SUBJECT: Response to Request for Additional Information dated October 7, 2005
Sumter Cement – Center Hill Plant
DEP File No. 1190041-001-AC (PSD-FL-358)
Proposed Portland Cement Plant in Sumter County, Florida

Sumter Cement Company (SCC) includes the following information in response to the Florida Department of Environmental Protection's (Department) request for additional information (RAI) dated October 7, 2005. SCC has included text from the Department's RAI in *italics* for clarity with SCC responses following each question.

Chart 2: SAC SO₂ Emission Data 2005

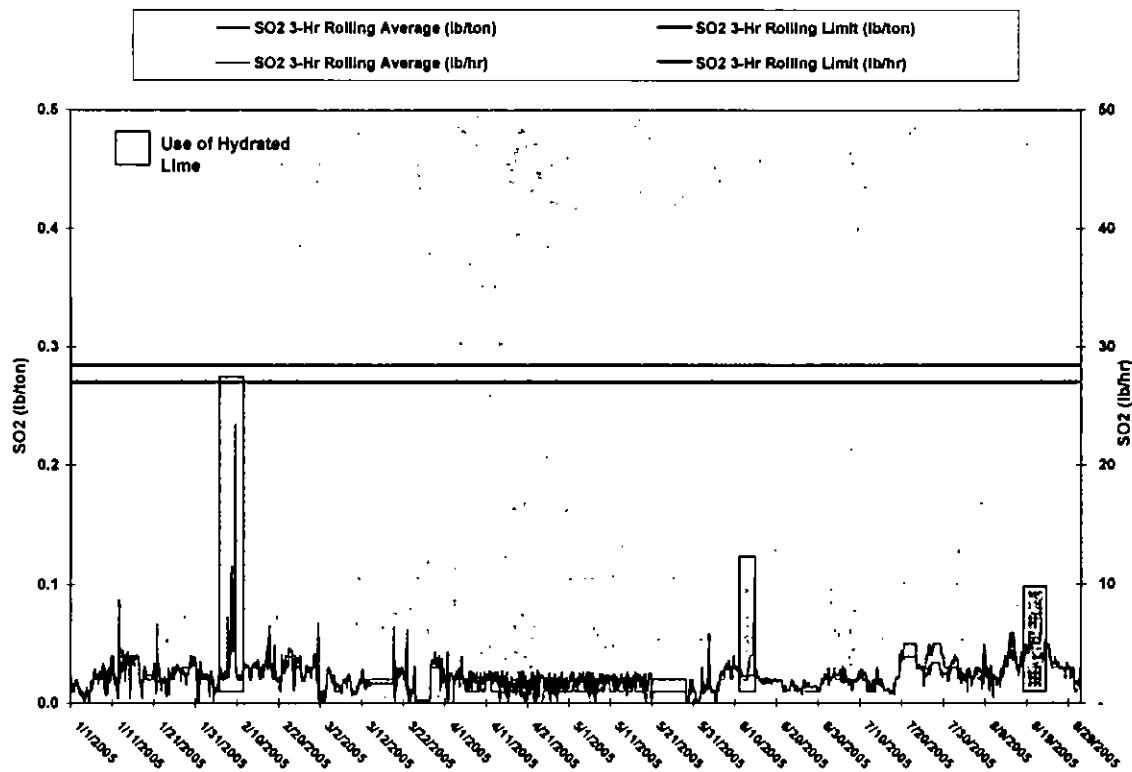
4. Please provide a disk that includes a summary of 2005 data for 24-hr-averaged SO₂ emissions in terms of lb/ton from operation of the SAC plant. Indicate instances when injection of hydrated lime was practiced and the total amount of hydrated lime actually used for this purpose in 2005.
[Rule 62-212.400(h)3., F.A.C.]

SAC closely monitors the sulfur inputs, but due to limited alkali the smallest shift in sulfur in limestone can cause the balance to be lost and excess sulfur to circulate in the raw mill/kiln system. SCC proposed to install the hydrated lime system as SAC has done as a means to insure compliance with the extremely low SO₂ limit. The use of the system would be very limited, with control of sulfur inputs being the means to insure long term compliance.

Chart 2 shows the SO₂ emission data for SAC for 2005.

Figure I: SCC Proposed Quarry Area

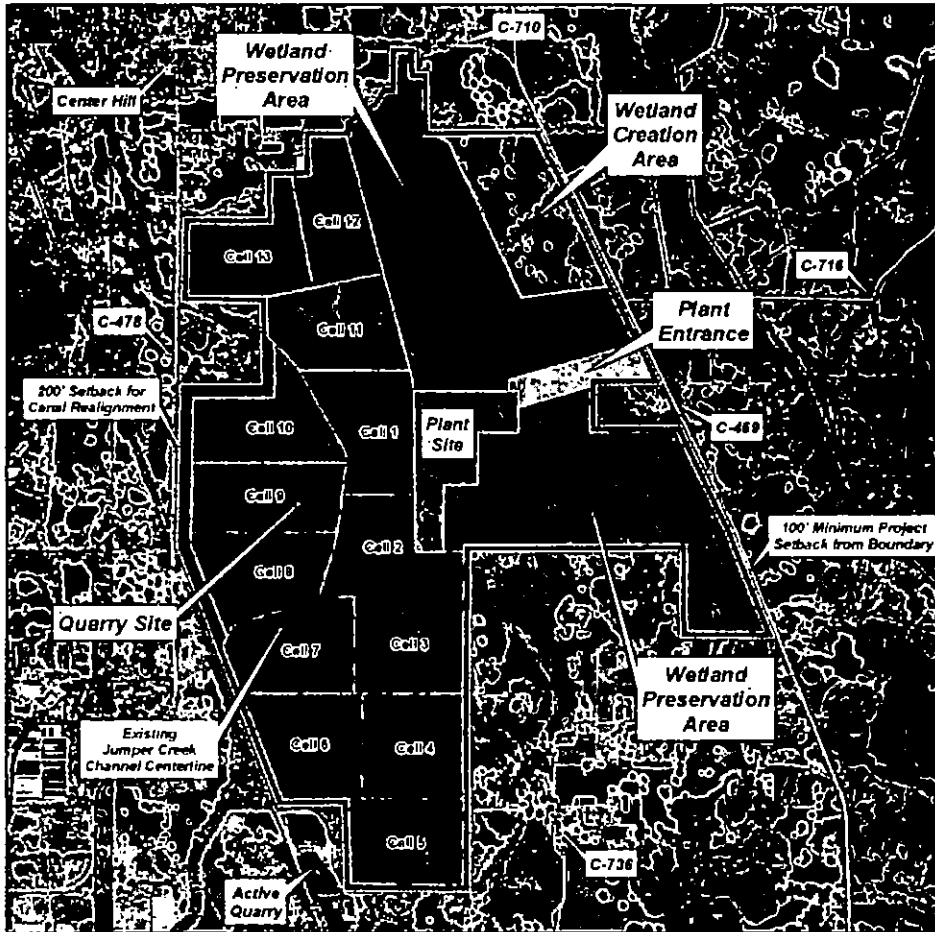
7. *Provide a qualitative if not quantitative discussion of the differences in sulfur and SO₂ generation potential due to raw materials differences between the quarries at SAC and SCC. [Rule 62-212.400(h)3., F.A.C.]*

As described in Response 3, SCC has conducted an extensive drilling campaign to identify the chemical composition of the possible quarry reserves for mix calculations and design of equipment as well as for possible concerns over VOC and SO₂ emissions. Due to the relatively low alkali content of the raw materials currently available, stringent monitoring of raw materials is the only means to insure compliance with the SO₂ limits proposed as BACT. This includes the quarrying of limestone and silica which are generally low in sulfur, however isolated pockets of material have been identified at SAC which are high in sulfur. Selectively quarrying and continuous monitoring of raw materials is required at SAC to insure these materials are not introduced into the system in improper ratios as to negatively affect the sulfur-alkali ratio. The same practices will be followed at SCC.

For SCC, the results of the quarry survey revealed that in areas where the limestone was present very little sulfur was detected. Some areas which did not present high concentrations of limestone contained sulfur levels similar to those found at SAC, which is predominately pyritic sulfur. SCC has designed its quarry around these areas as shown in the following Figure.

SCC Road Segment Chart

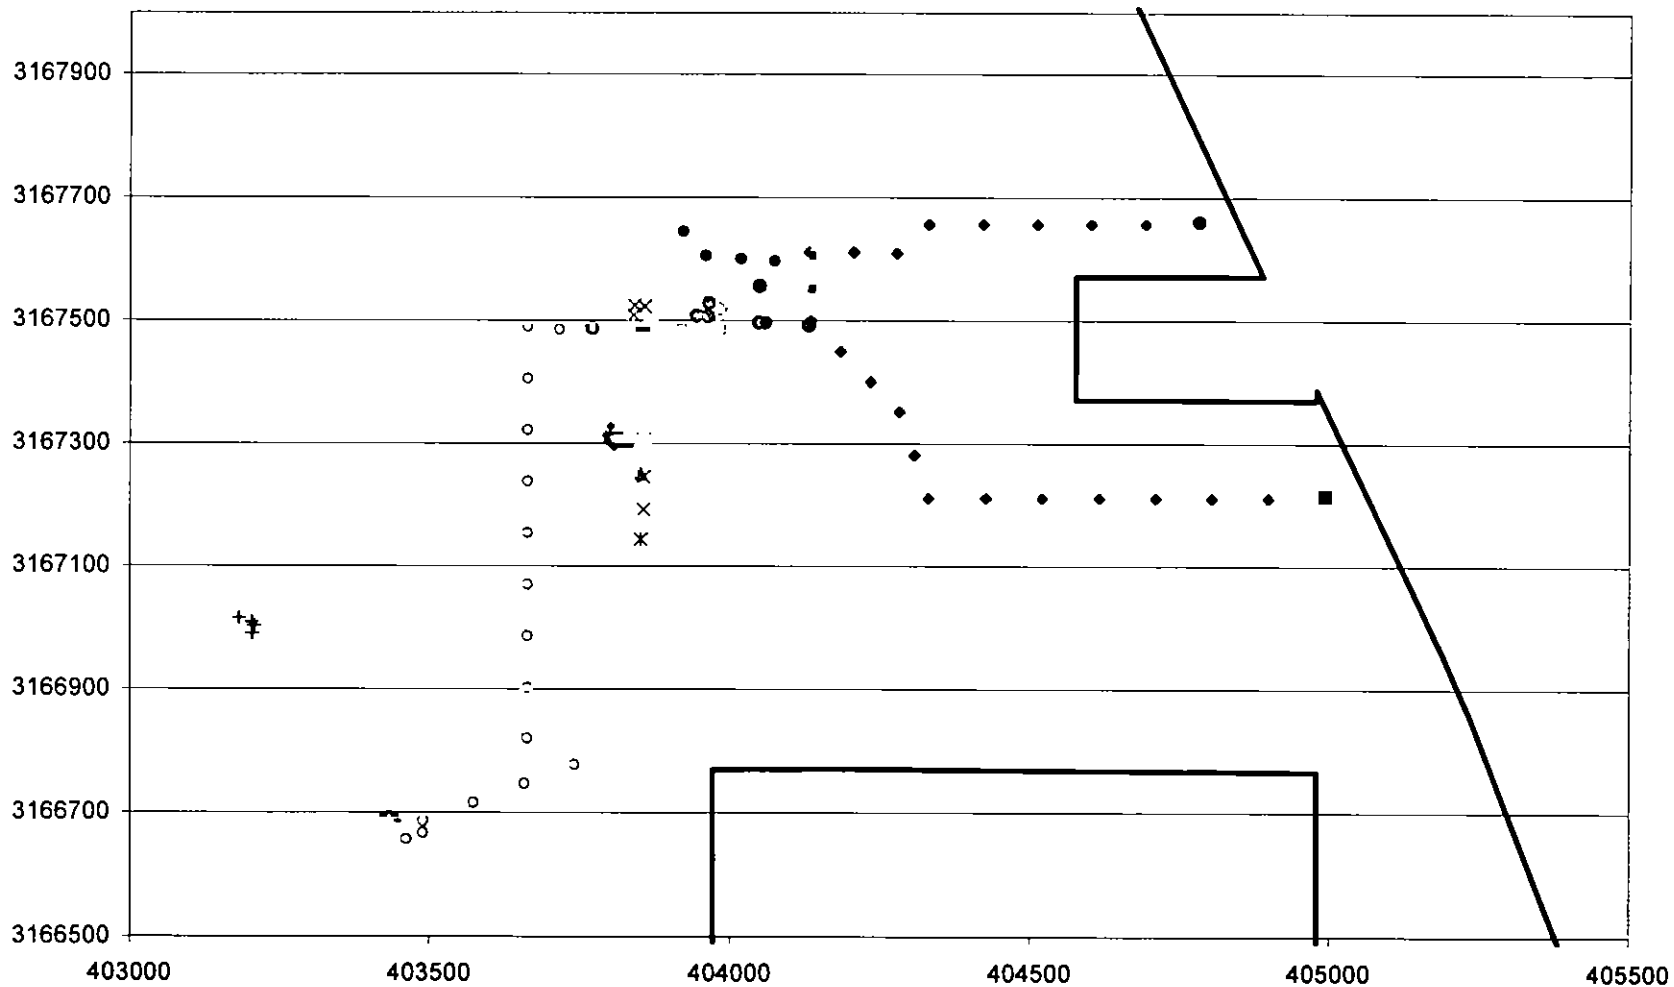
23. *Please provide a diagram showing each road segment, its location and its emission parameters.*
